## ENGINEERING REPORT

NO: 21272D-1-0318-10

Re: Critical Review of Ballast Design Calculations and Roof Top Placement Drawings for the Ecofoot5D® Solar Panel Support System, Assured Solar Energy – (111 West St.) 111 West Street Portland, Maine; CBC Report No. 21272D-1-0318-10

Date	2018-03-16	Sheet	S-1.0
Scale	NTS		
Drawn By:	KRIS JONES

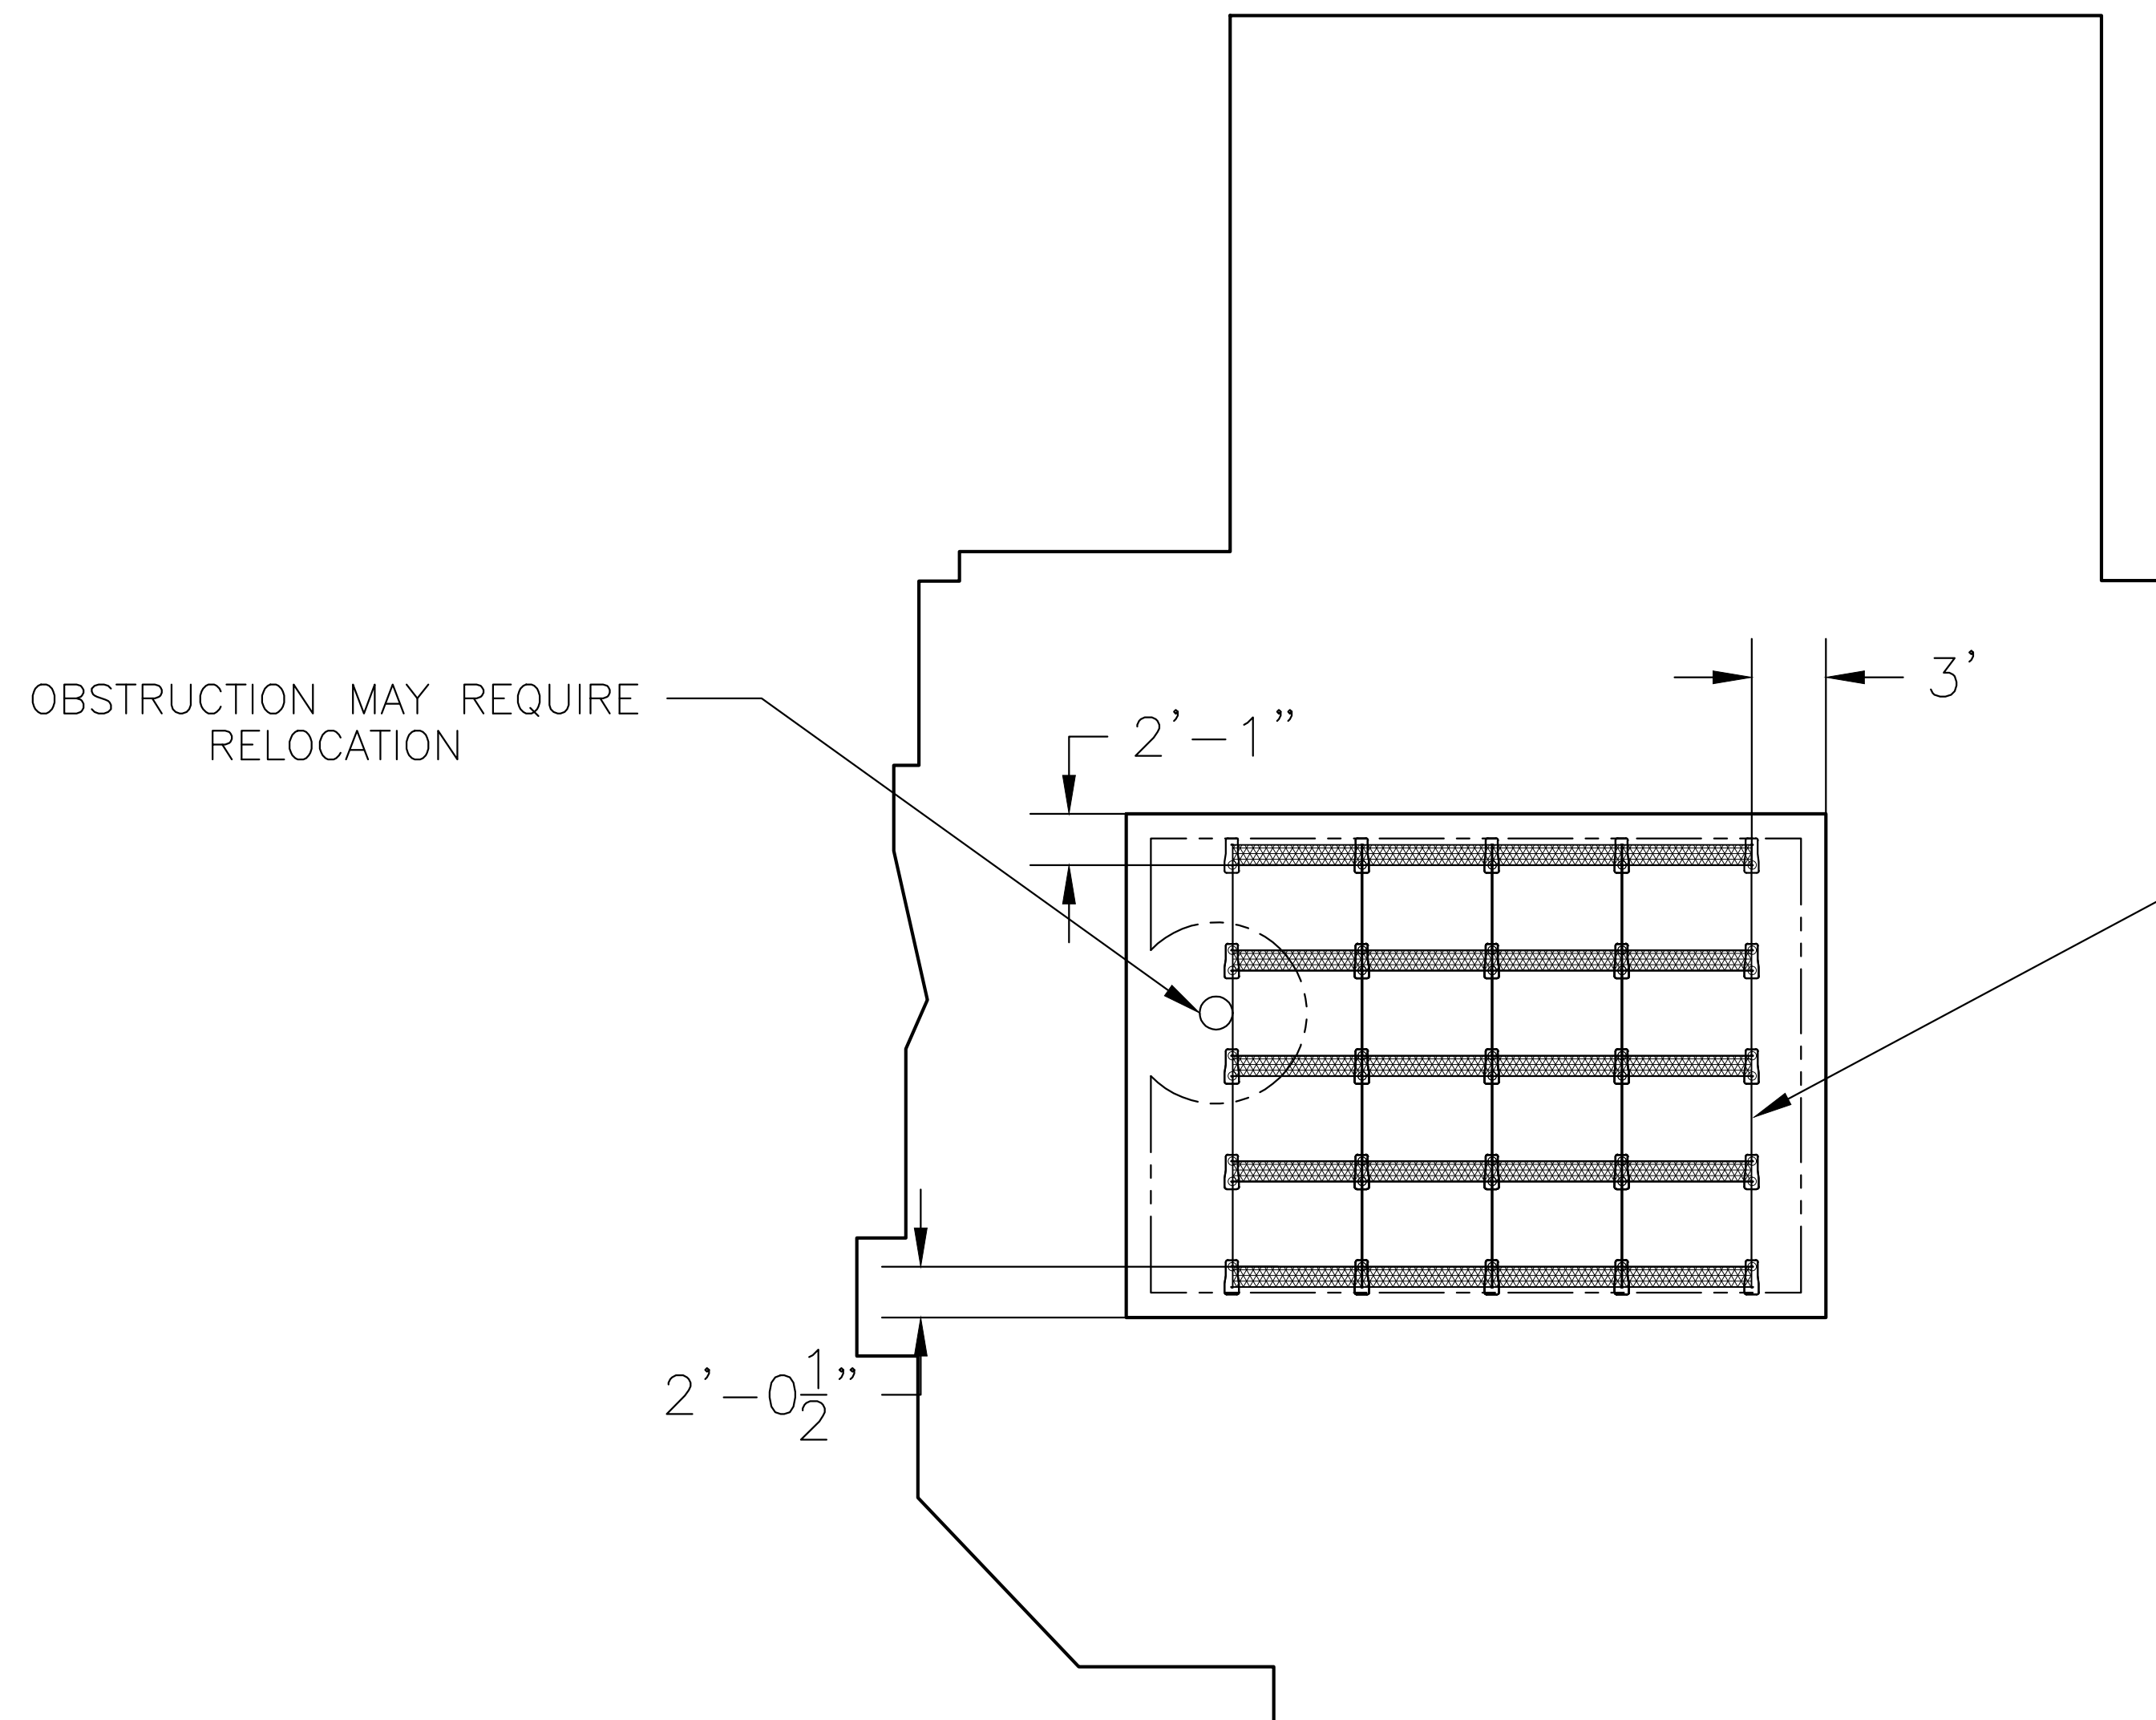
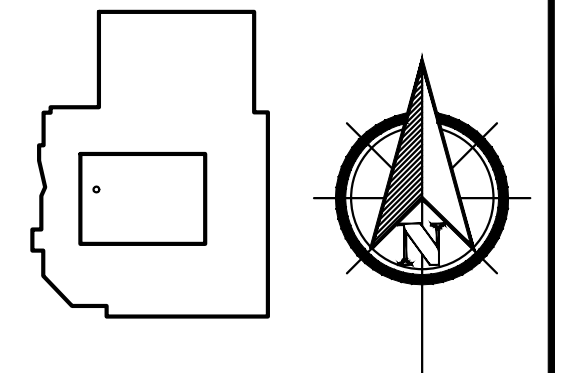
Based on a critical review of the ballast design calculations, it is the opinion of CBC that said calculations have been performed and prepared in accordance with the applicable provisions of the referenced standards and accepted industry practices. The calculations are included in Appendix A. It is also the opinion of CBC that the Ecofoot5D® placement shop drawings have also been performed and prepared in accordance with the applicable provisions of the referenced standards and accepted industry practices. The drawings are included in Appendix C. CBC has accordingly signed and sealed this report and the Ecofoot5D® placement shop drawings. As such, CBC is the Engineer of Record for the structural analysis of the Ecofoot5D® system for the above referenced project.
